Our Ref: 14683-HISC-EJE RtS2 (rev.1)
Date: 9 March 2026

RE: **Response to Submissions 2 (RtS2) – Hunter Indoor Sports Centre (SSD-65595459)**

This architectural statement supports the Response to Submissions 2 (RtS2) for State Significant Development Application (SSD- 65595459) for the proposed Hunter Indoor Sport Centre (HISC) at 2 Monash Road and 24 Wallarah Road, New Lambton.

Figure 43 - Ground Floor Permeability (bright-blue mark-ups)

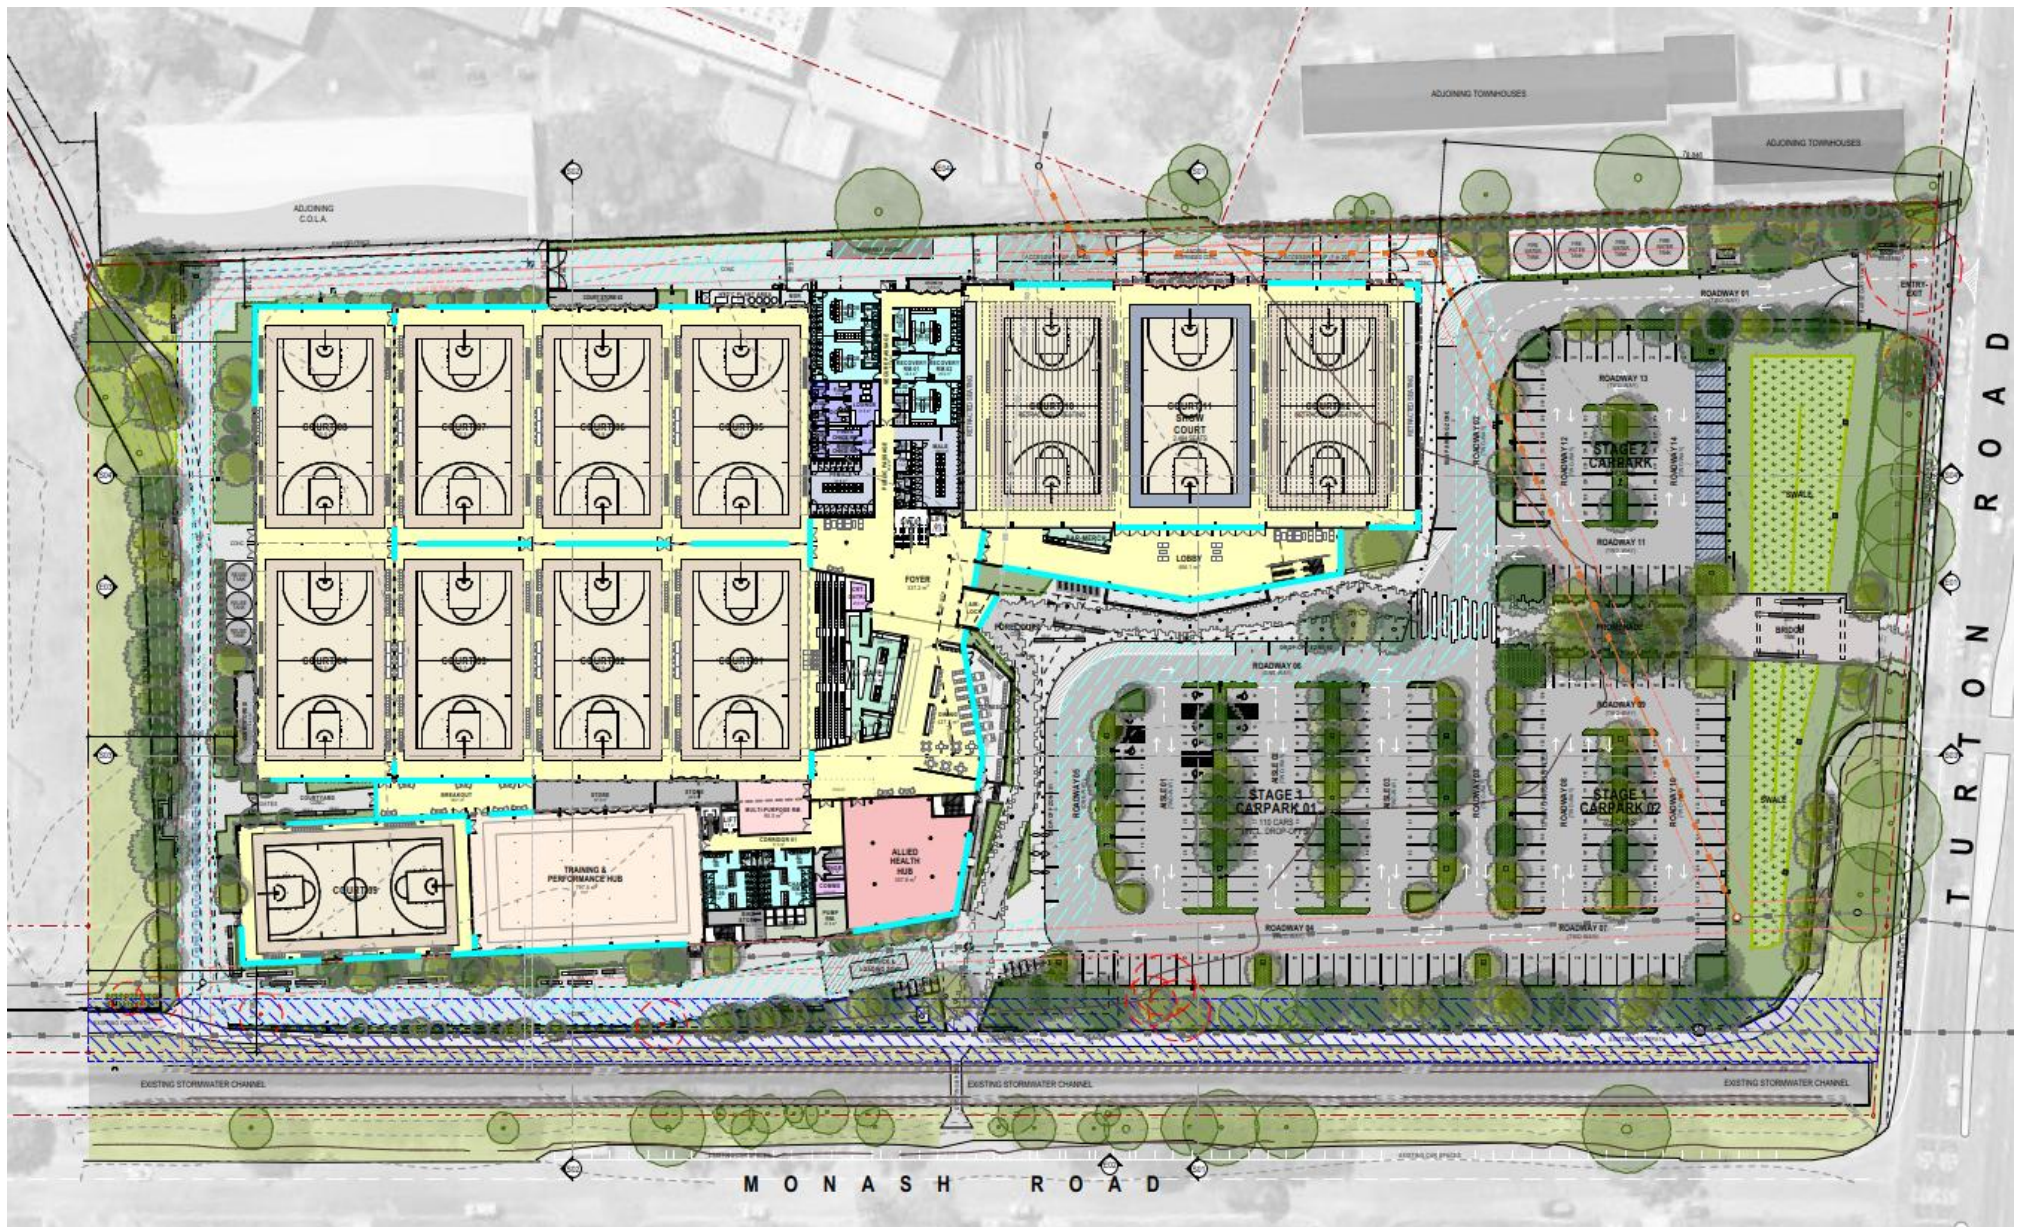
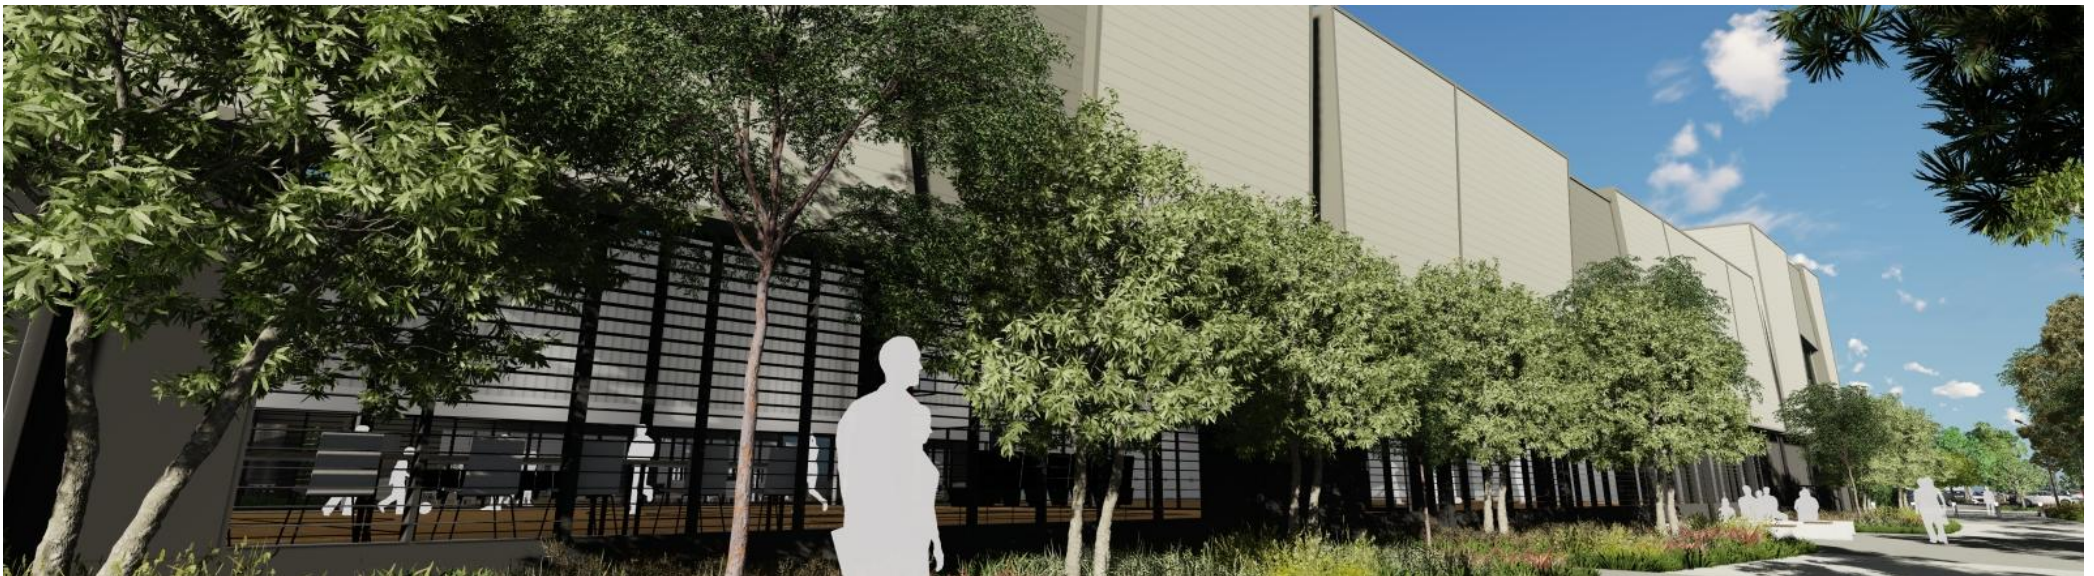
The building remains internalised with limited passive surveillance or public facing uses along the Monash Road frontage. Provide further meaningful activation and permeability along this edge of the site.

Internalised planning is a result of the facility's function (i.e. a sports stadium, with lighting & glare control requirements). However, substantial external facade glazing, & internal glazing between courts, has been provided, to allow for both external & internal passive surveillance & permeability.

The 1:500 scale of the submitted Floor Plans may possibly be hard to interpret, however, the majority of the southern façade at ground level facing Monash Rd, is glazed or louvered & capable of being permeable (e.g. Court 09, T&P Hub, Allied Health Hub). See marked-up part plan below (Fig.43), with bright-blue mark-ups indicating external & internal permeable walls (glazed or louvered).

EJE drawings A1016-A1023 were added to the drawing set in the first Response to Submission (RtS1), to provide further clarification, & to explain the proposed extent of external permeability of the facade. EJE dwgs A1033-A1034 were also added, to show the proposed internal permeability. See Figs 44-51 below, from the above noted drawings.

Figure 60 – SDRP Concept Submission (Feb. 2024)

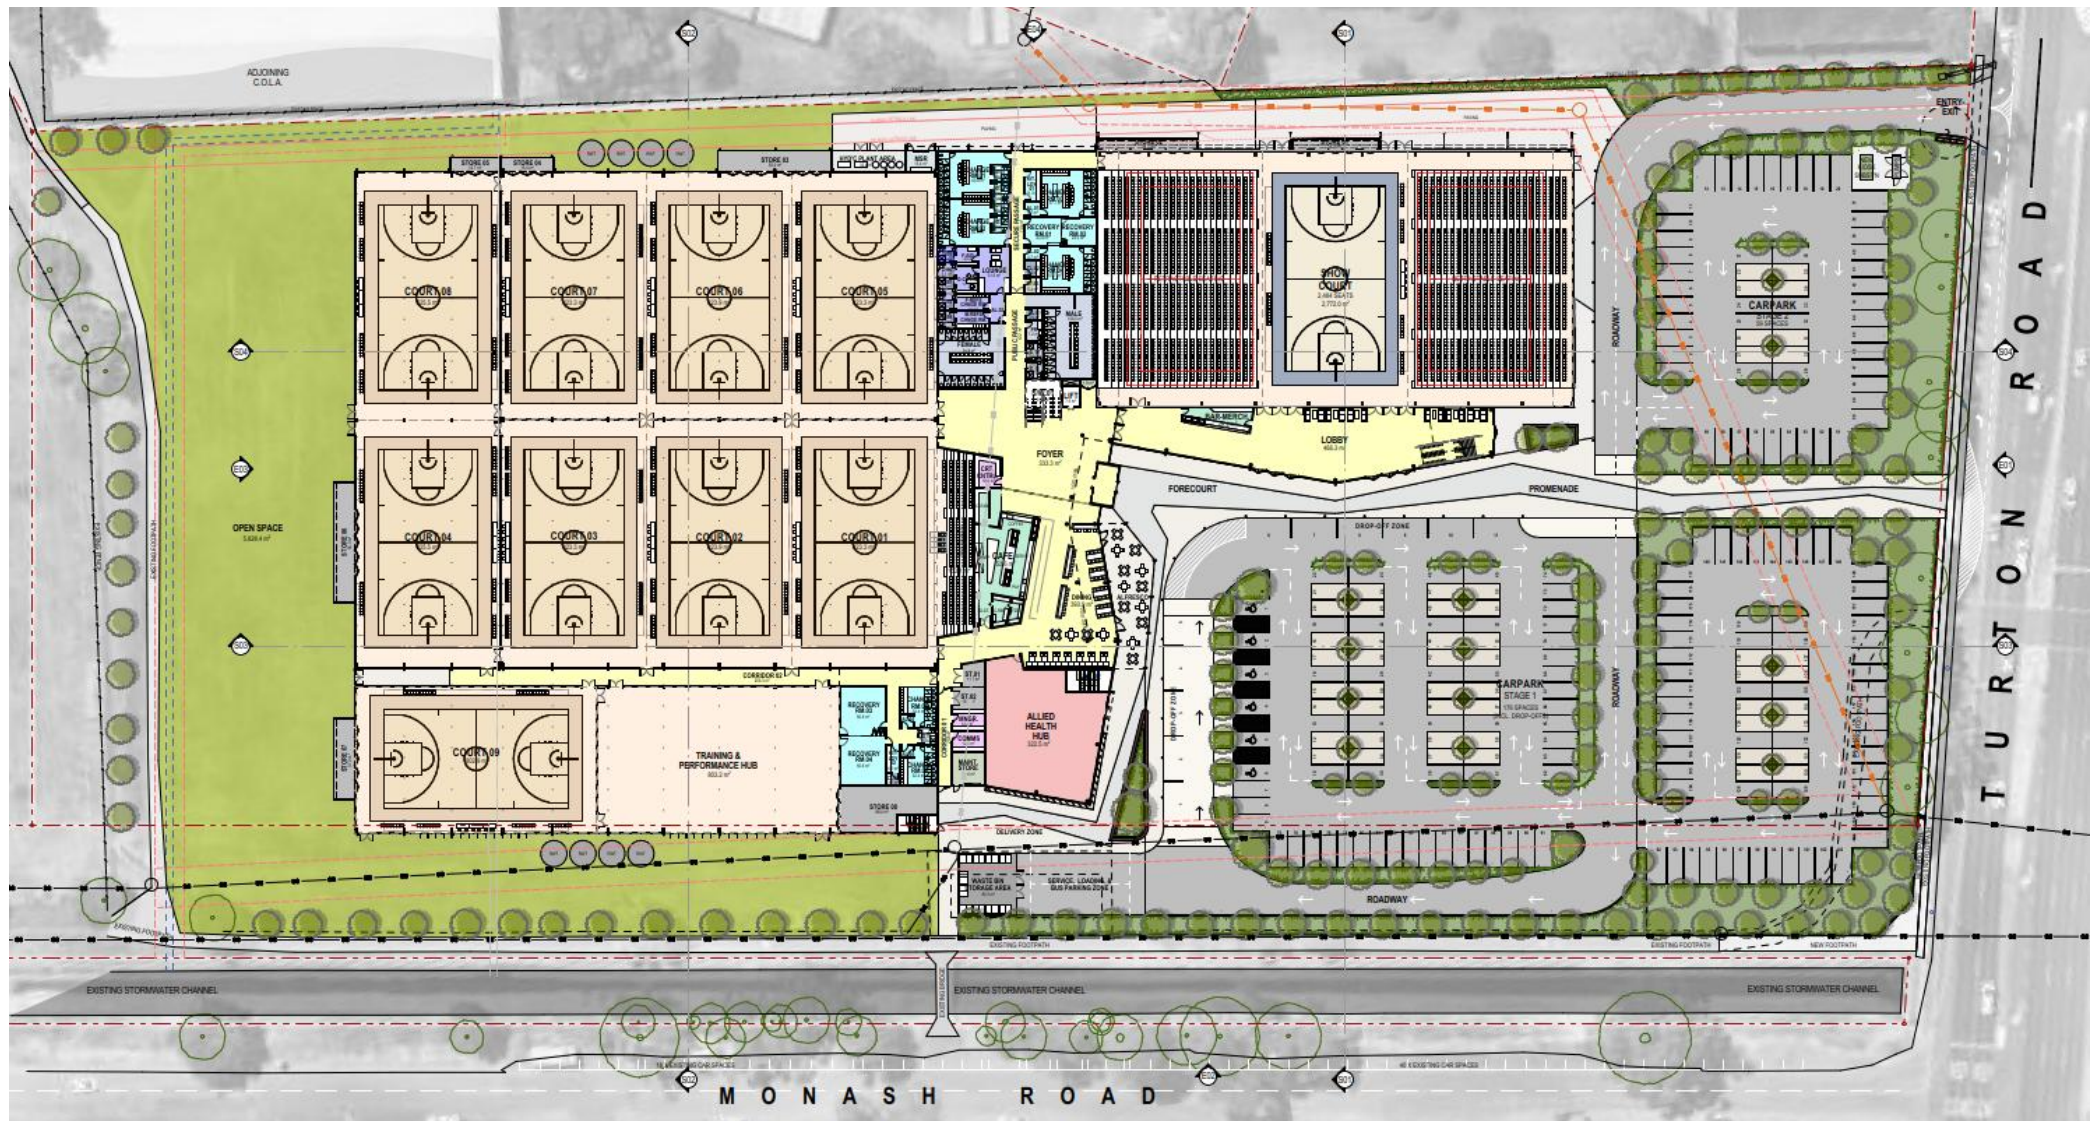
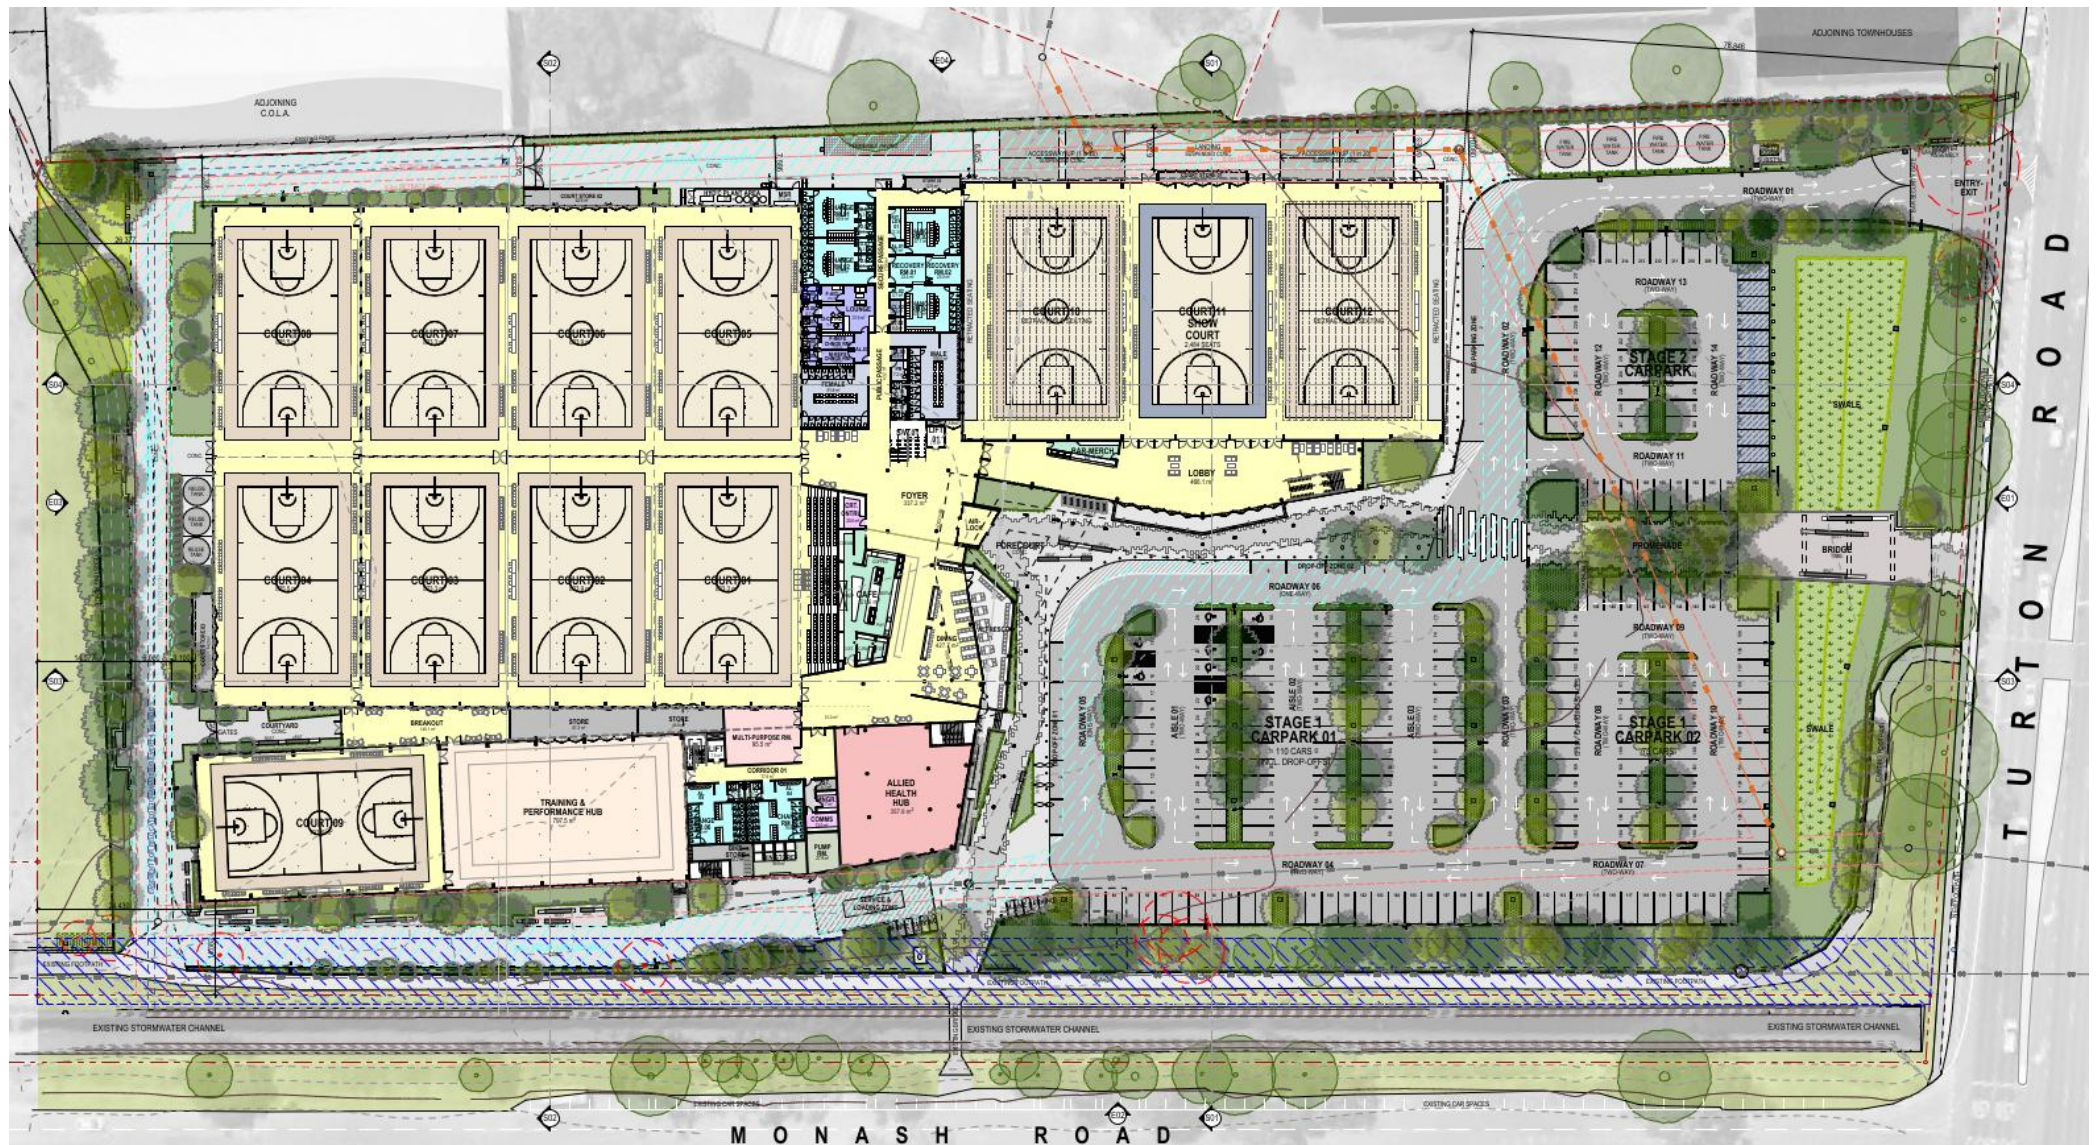
Develop the elevational treatment and articulation of the northern and western façades to provide an appropriate interface with the townhouses and school and reduce adverse visual impacts.

The built form was revised for the original SSDA submission, to address the SDRP comments as provided at concept/pre-DA stage. The southern High-Performance wing was twisted in its plan orientation & massing at this stage (prior to the original DA submission), to create additional external visual interest to the western facade & massing, & to open-up the internal planning for the creation of internal break-out spaces, & to link to the external break-out spaces adjoining. See Fig.s 60-62 below.
